RE: 5th Right Longwall Development, Deer Creek Mine

MINOR MODIFICATION TO:
MINING PLAN APPROVED BY
BUREAU OF LAND MANAGEMENT

PACIFICORP ELECTRIC OPERATIONS FUEL RESOURCES DEPARTMENT <small>P.O. BOX 26128 SALT LAKE CITY, UTAH 84126-0128</small>	
DEER CREEK MINE 5TH RIGHT R2P2 MODIFICATION	
DRAWN BY: J. GARRETT	DU1292B
SCALE: 1" = 300'	DRAWING 6
DATE: MAY 9, 1991	SHEET 1 OF 1 REV.

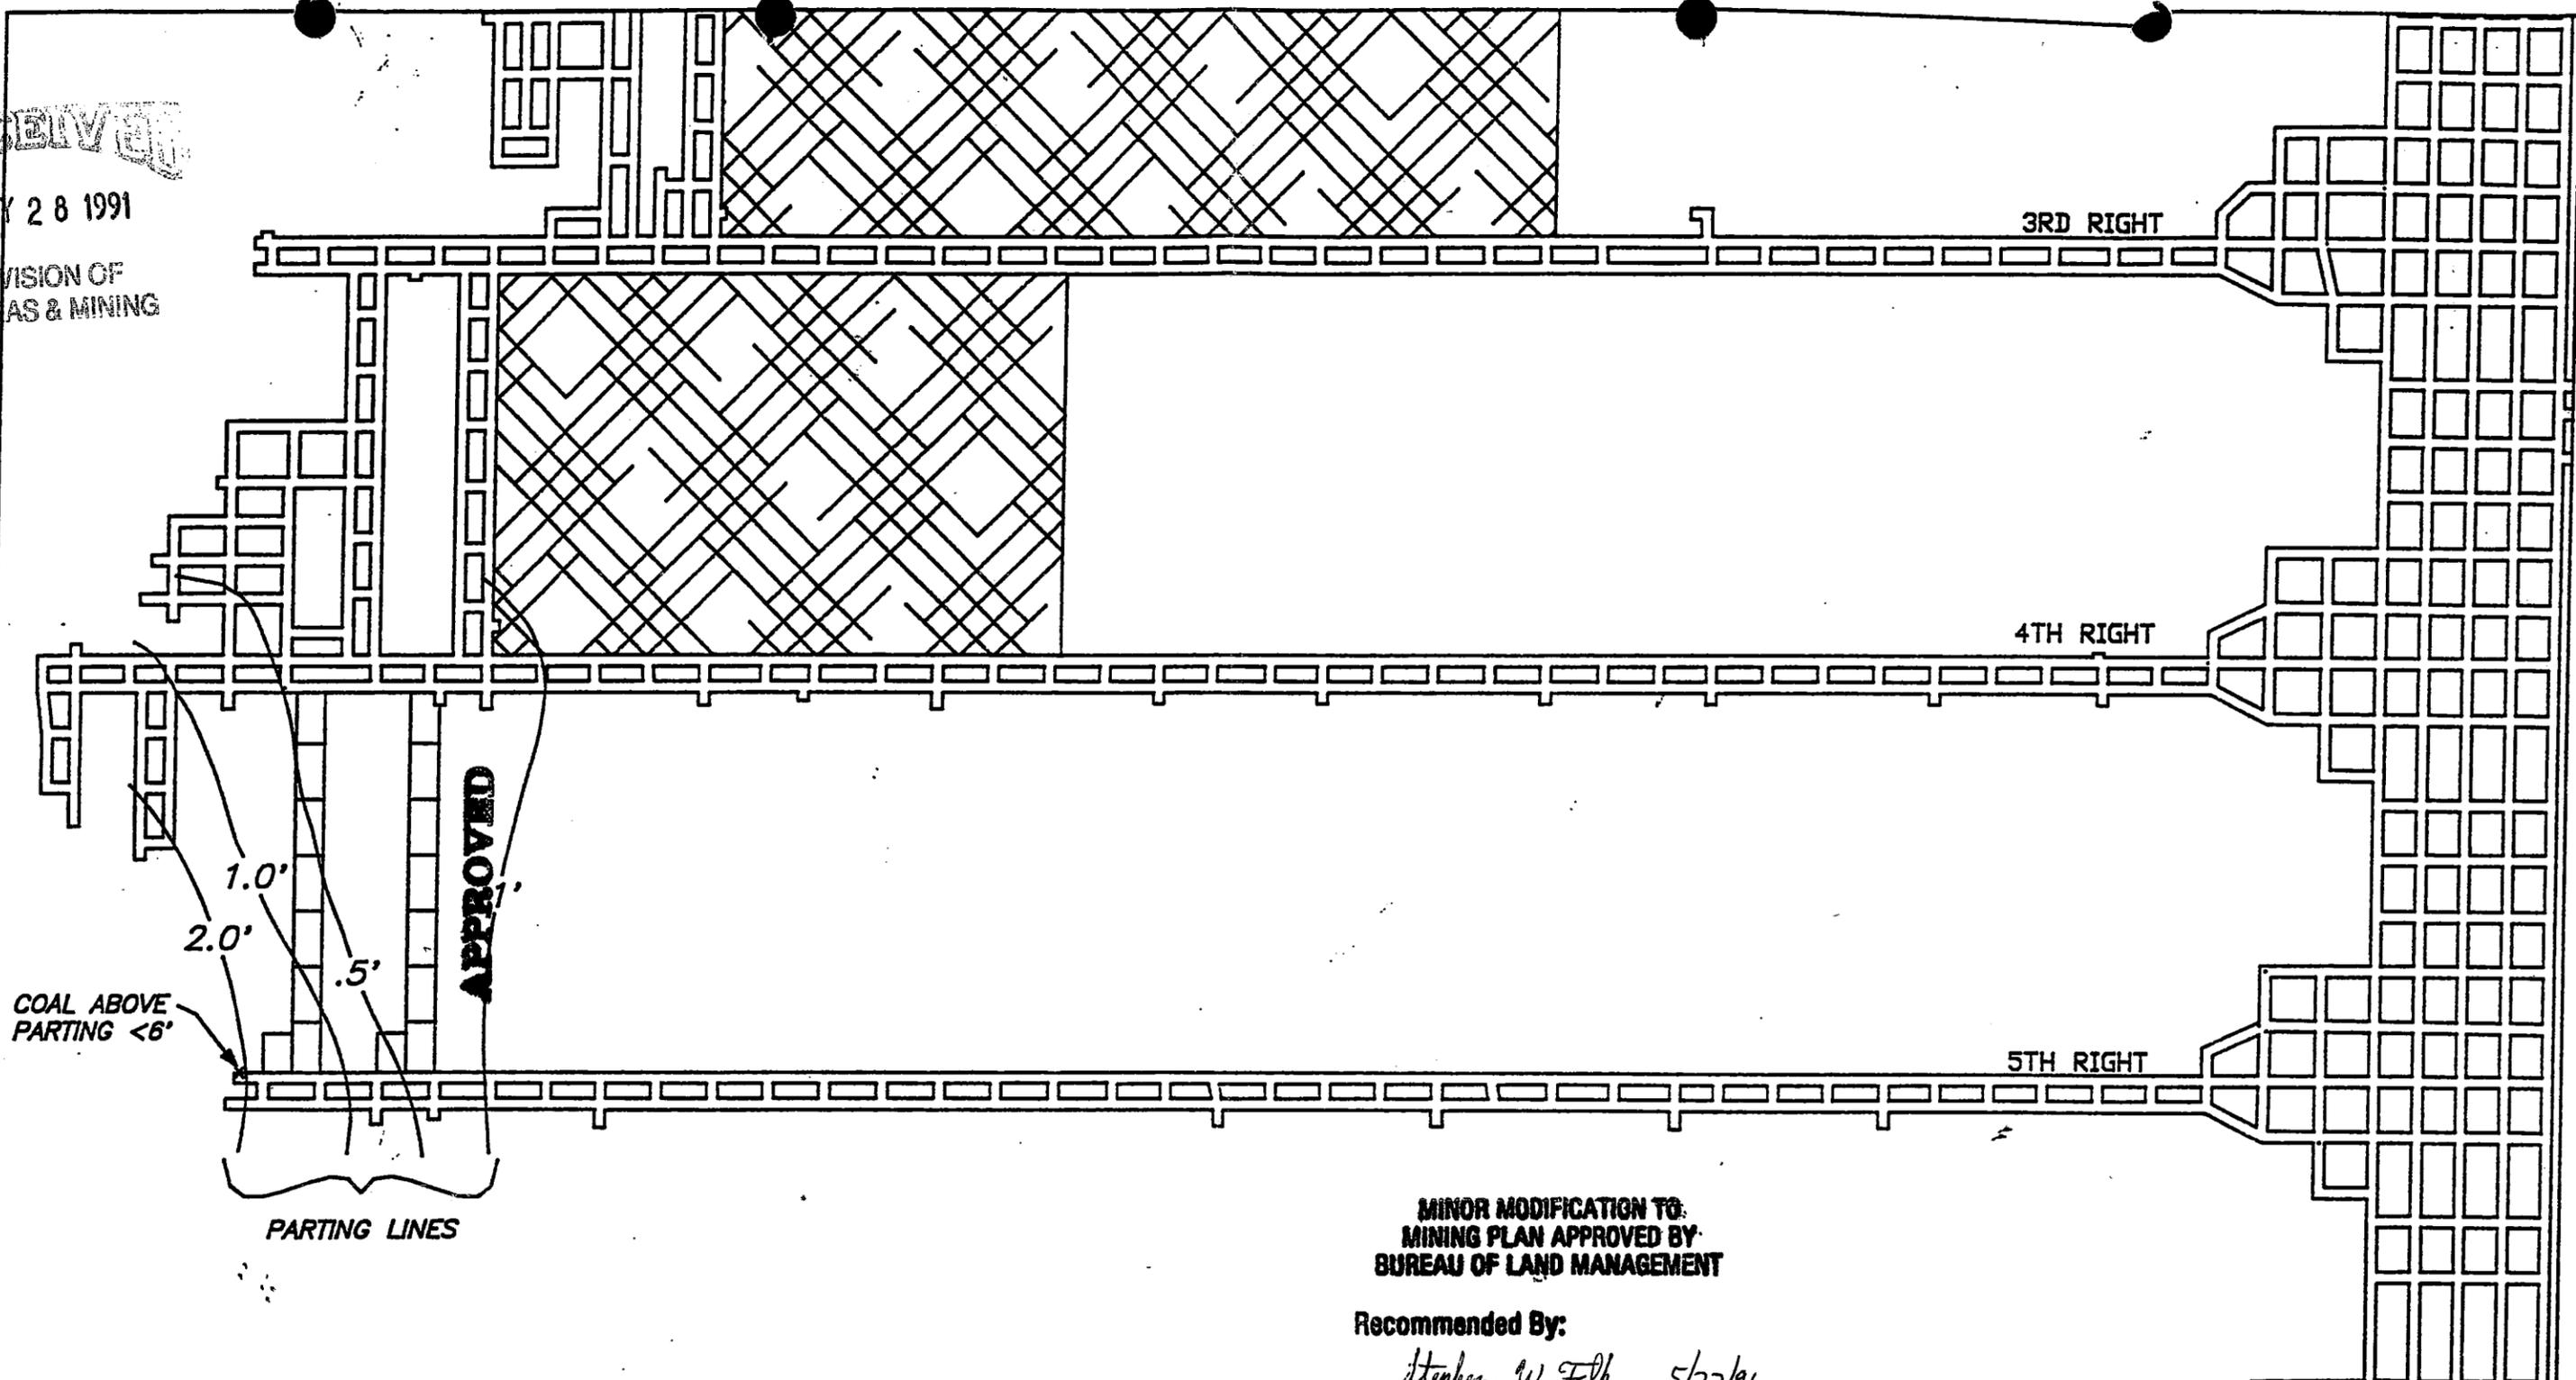
The proposed modification calls for shortening the planned 5th Right longwall panel, located on Federal lease U-084923, approximately 480 feet. The longwall set up entry would be mined at cross cut 35 with the bleeder entry beginning at cross cut 38. The previous plan was to set up the longwall at cross cut 40 with the bleeder entry at cross cut 42.

PacifiCorp's justification to modify the mine plan is that a rock split was encountered in the Blind Canyon Seam while developing the 5th Right gate road entries. It is contended that the thickness and hardness of this material has precluded further development of the longwall panel.

The conditions in 5th Right were verified by BLM personnel during an inspection on May 7, 1991. Coal thickness at the face past 38 cross cut was down to 5 feet. The thickness of the rock split was measured (2 feet thick) at the intersection of cross cut 38 where the miner had tried to mine into the split and exposed the rock. The continuous miner was being repaired at the face from damage sustained in mining the hard rock parting. Based on these conditions, the BLM agrees that setting up the 5th Right longwall face at cross cut 35 is warranted.

In conclusion, BLM has determined that the requested change to the 5th Right longwall panel is in compliance with the Mineral Leasing Act of 1920, as amended, the regulations at 43 CFR 3480, the lease terms and conditions, and will achieve maximum economic recovery of the leased Federal coal. Therefore, the modification to set up the 5th Right longwall at cross cut 35 is approved. A copy of the approved modification and mine map is enclosed. PacifiCorp is not authorized to modify the 6th and 7th Right gate entries until the the information discussed is submitted for approval.
